Economic and Social Council

163rd session

Geneva, 24-27 June 2014

**World Forum for Harmonization of Vehicle Regulations on
its 163rd session**

Annex 5, Figure 5, amend to read:

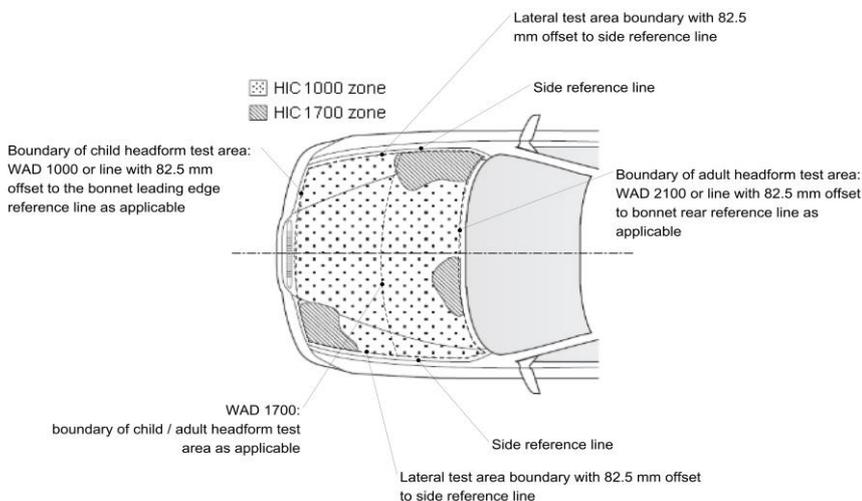
Annex 4, paragraphs 1.1. and 1.4., square brackets shall be removed.

"Figure 5

Example of marking of HIC1000 zone and HIC1700 zone
